From: Reichardt, Daniel A (DEC)
Sent: Friday, July 27, 2012 2:25 PM
To: Randlett, Susan A (DEC)
Cc: Paul Weisner; Graham Knapp; Allan Paukan; City of Chefnak
Subject: RE: Chefnak Pump House Structural Support for Tank Move

Per your request today, here are some preliminary layouts and calculations for laying out steel support beams under the floor to support the relocated 4000 gal water storage tank.

CHEFORNAK PILE
 AND STRINGER BEAM
 PLAN

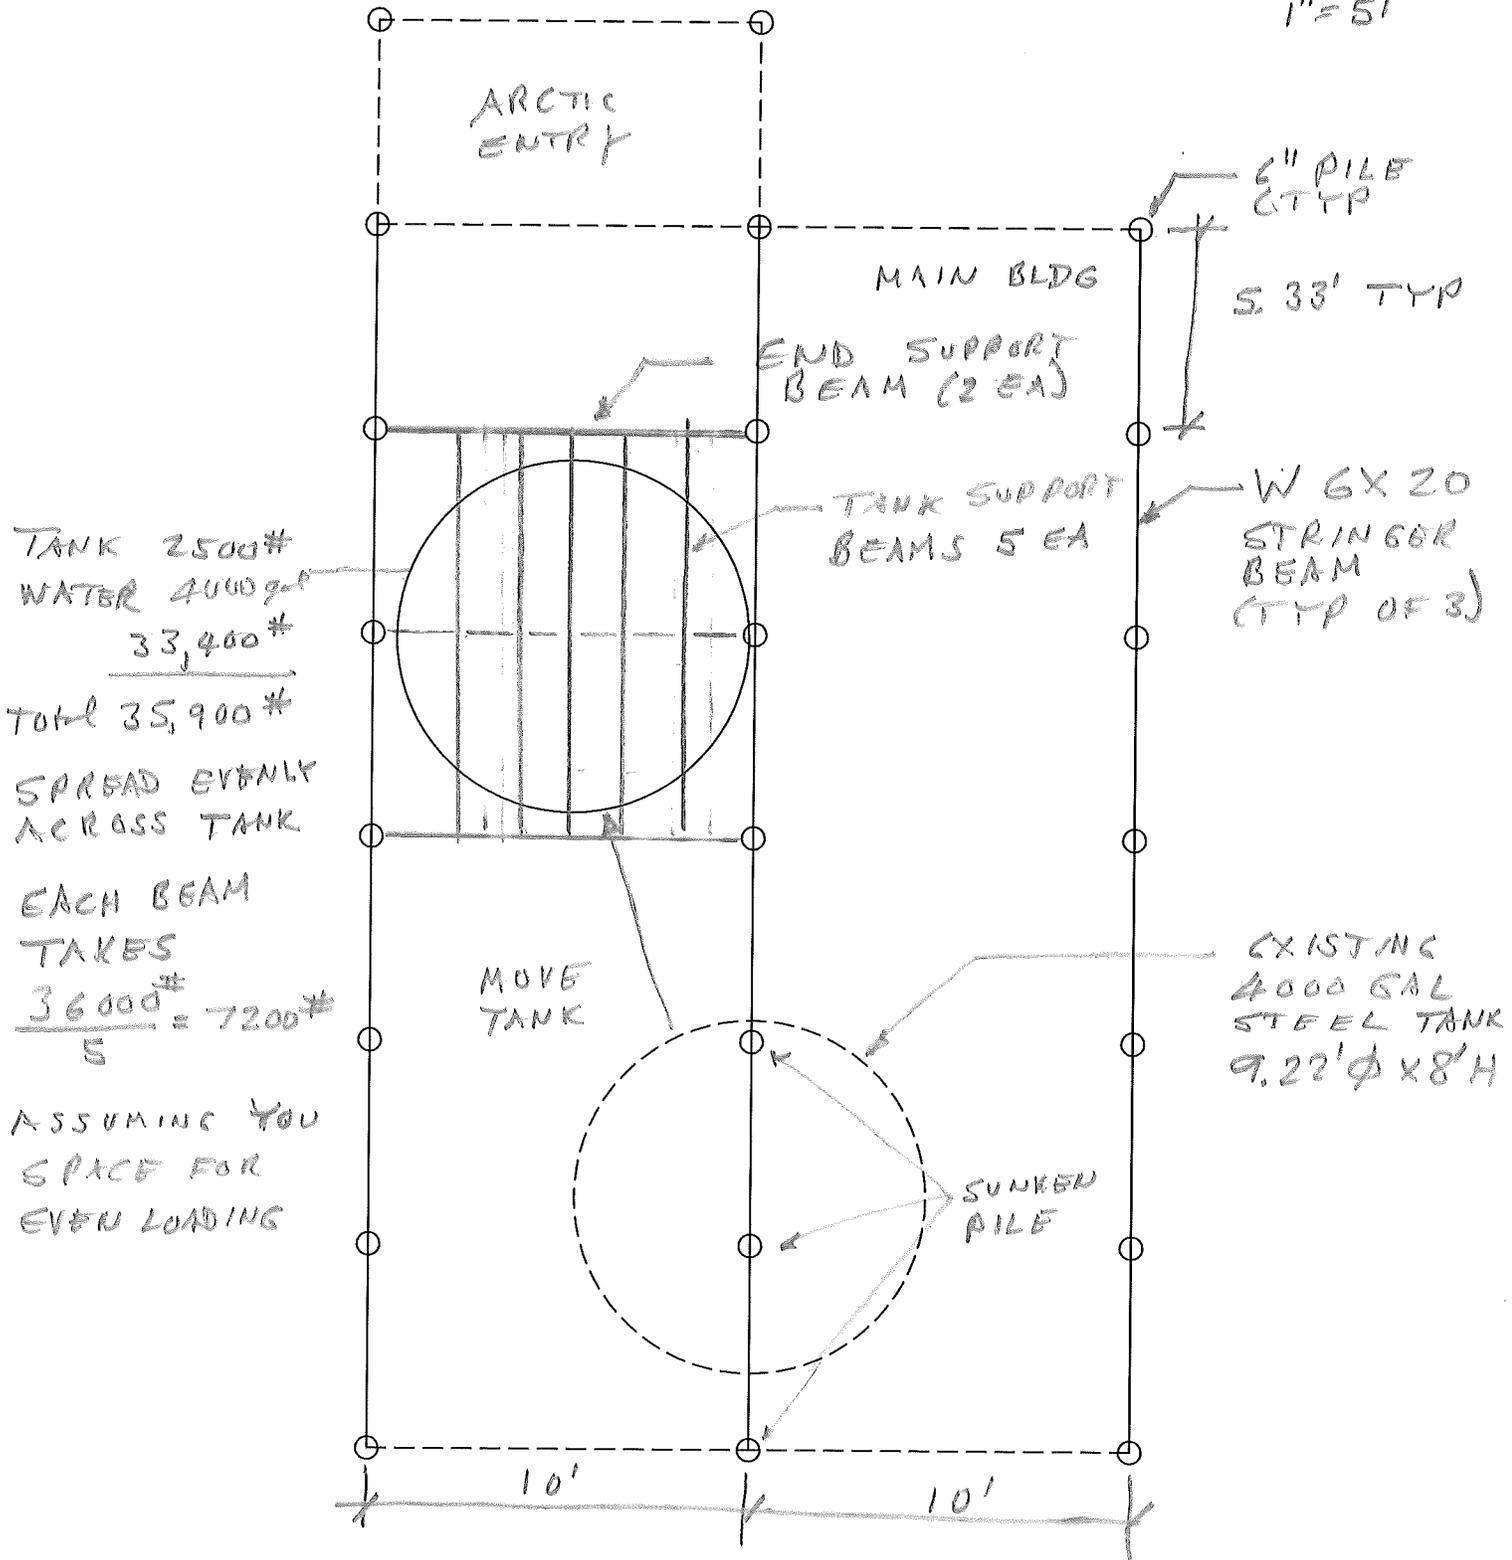
This work does not require plan submittal or approval by the drinking water program. However, prior to procuring the plastic liner for the water tank, please submit information to me that describes the liner material and any certifications that may be in place regarding it's suitability for contact with drinking water. If available, you should use a liner that has been certified as being compliant with NSF/ANSI Standard 61.
